A Report Prepared for
MESSING AND INWORTH ACTION GROUP LIMITED

In respect of
**A12 Chelmsford to A120 Widening Scheme,
DCO Application (TR010060)**

Transport and Highway Infrastructure Review

February 2023

Figure 4.1 – Overview of Proposed Junction 24 Works

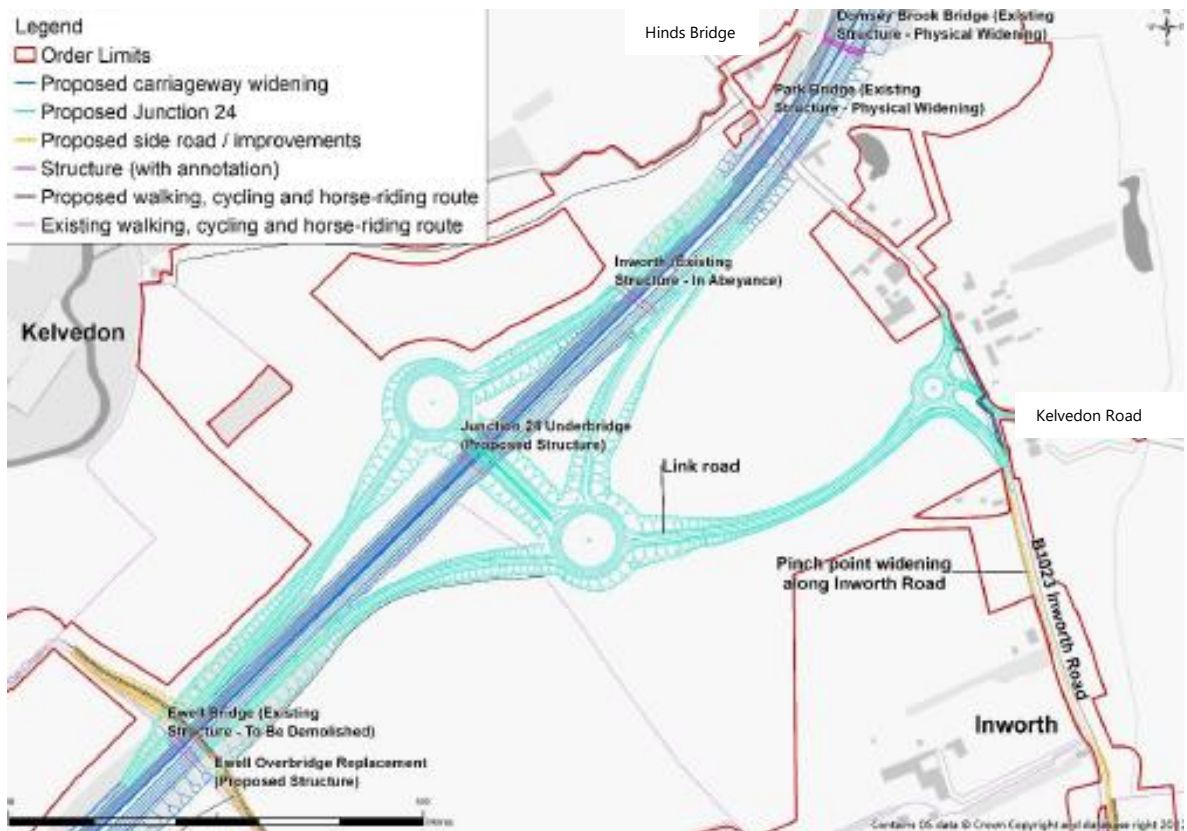
- 4.4 The design proposal with linked roundabouts to the northern and southern side of the A12 would provide all movement access to the A12 via the proposed connecting link to the B1023.

Figure 4.2 –Proposed B1023 Inworth Road Works

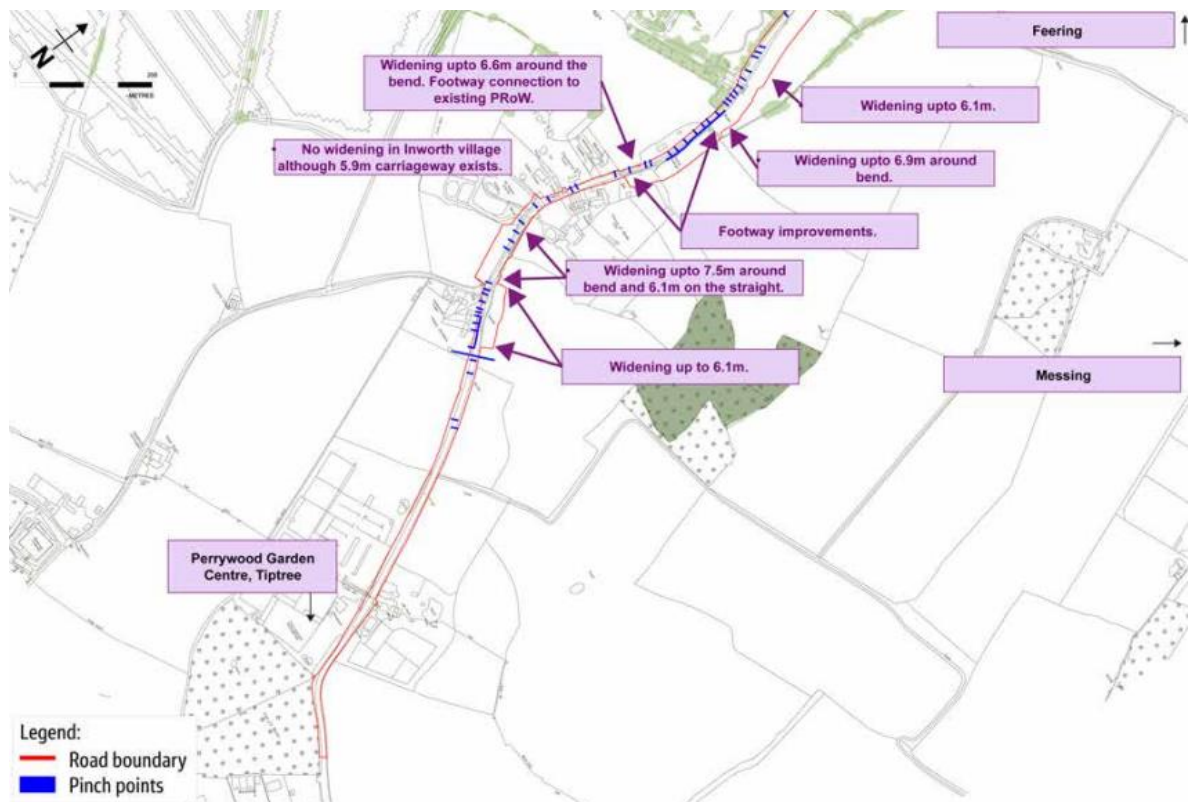
- 4.28 The proposals are to widen a number of pinch points along Inworth Road by between 0.3m and 2m. This includes widening straight sections of the road to provide a minimum of 6.1m carriageway width and widening bends to accommodate two large vehicles passing in opposite directions. New drainage is proposed as part of the widening proposals. An overview of these works and the pinch point locations is shown in **Figure 4.2**.

- 4.30 To assess fully the proposed pinch point improvement scheme a more detailed and larger scale design drawing is required, as opposed to the one currently presented at Sheet 20 of the General Arrangement Drawings.

SCALE	DATE	DRAWN	CHECKED	APPROVED
1:1000	13.09.22	RC	JH	JH
JOB NO:	DRAWING NO:	REVISION:		
2207-43	SK02	-

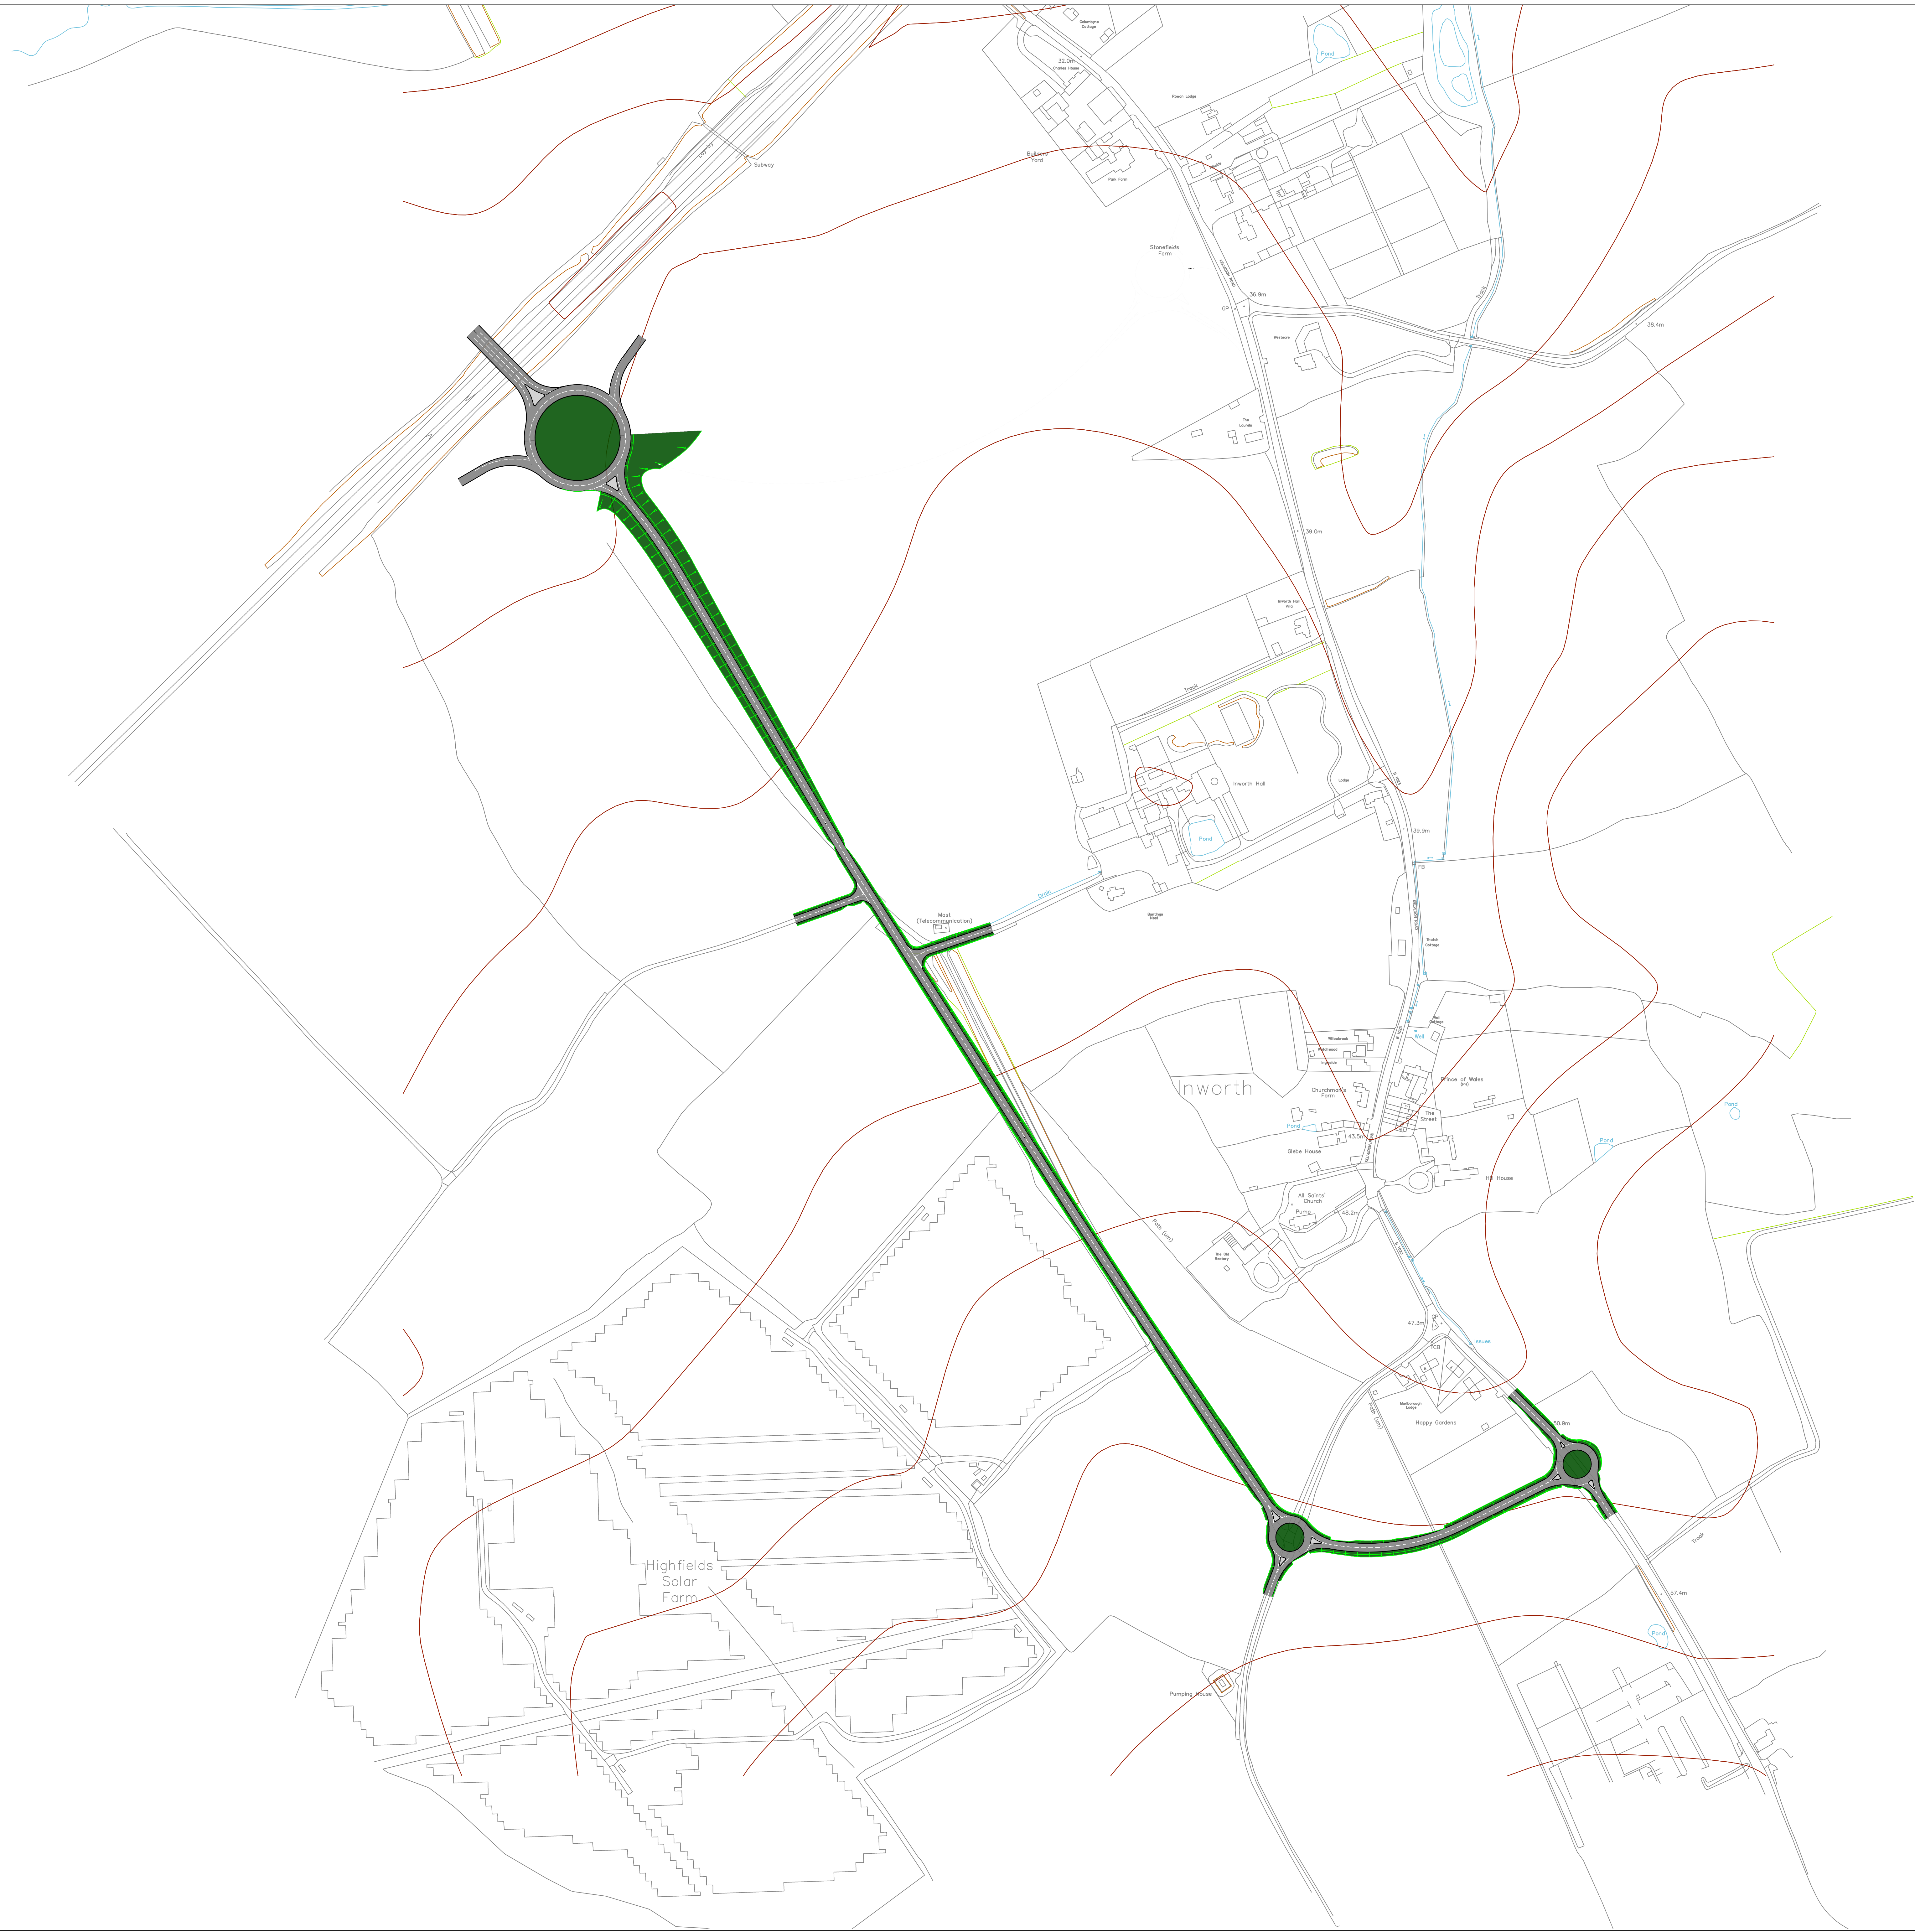
- 4.15 TPA has reproduced the proposed roundabout design (**2207-043 SK02**) to help understand the potential design issues outlined above, with a copy of this drawing presented within the drawings section of this report.

- 4.16 With reference to this drawing, it is evident that land outside of the Order Limit along with buildings/structures located on this cause a significant restriction on forward visibility for vehicles entering or leaving the northern arm of the B1023.

- 4.22 The curvature of the A12 Inworth Link Road and the SLTL contribute to provide a very acute entry angle of 5°, such an acute angle is not compliant with DMRB standards and would require drivers to look back over their shoulders, presenting opportunities for missed vehicles and an associated increase in the risk of accidents.

Showing the
GENERAL ARRANGEMENT
 CH. 30700 TO 32200
 SHEET 14 OF 21

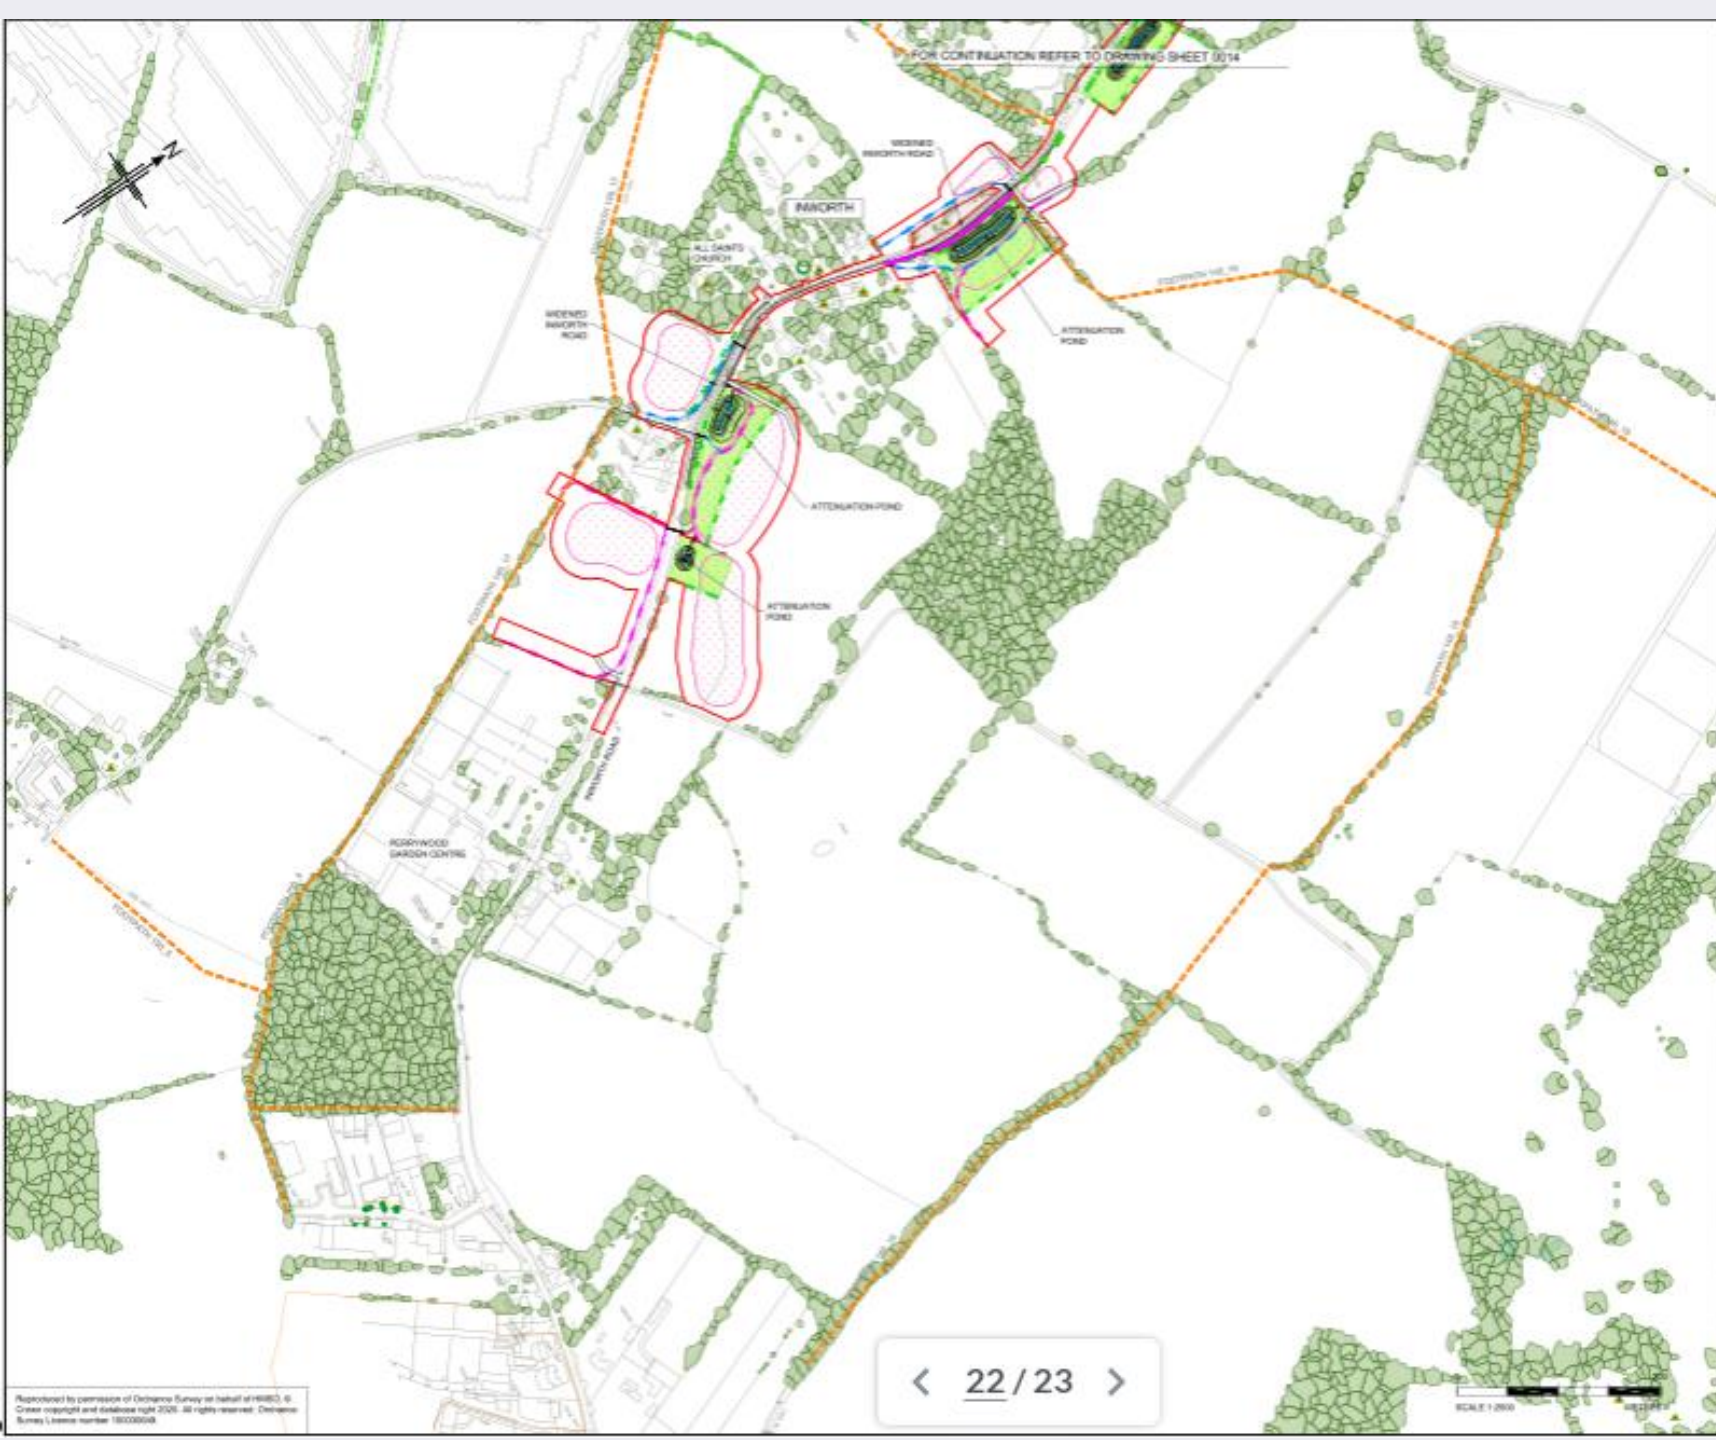
- 4.2 The proposed J24 Works are detailed on Sheet 14 and Sheet 20 of the 'General Arrangement' Plans [Document Reference: TR010060/APP/2.9] prepared by NH for the DCO Application. An overview of these works is shown in **Figure 4.1**.
